SUBJECT: REQUEST FOR ADDITIONAL INFORMATION LETTER NO. 4 - EXELON
EARLY SITE PERMIT APPLICATION FOR THE CLINTON ESP SITE (TAC NO.
MC1122)

Exelon Early Site Permit Application
Site Safety Analysis Report (SSAR) Section 2.3, Meteorology
Requests for Additional Information (RAI)

SSAR Section 2.3.1, Regional Climatology

RAI 2.3.2-3

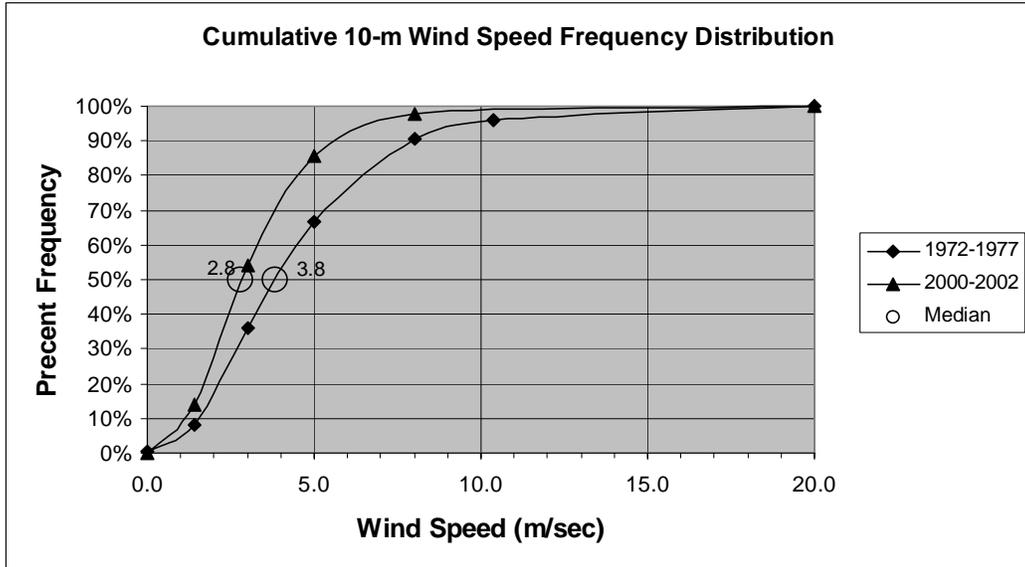
The onsite 10-m wind speed frequency distributions presented in SSAR Table 2.3-8 show a general shift towards lower wind speeds in the more recent data. In particular, a plot of cumulative wind speed frequency distribution shows a median (50 percent) wind speed value of 2.8 m/sec for the 2000-2002 period of record as compared to a median wind speed value of 3.8 m/sec for the 1972-1977 period of record. Please explain what might have caused these differences in reported wind speed frequency distributions between these two periods of record.
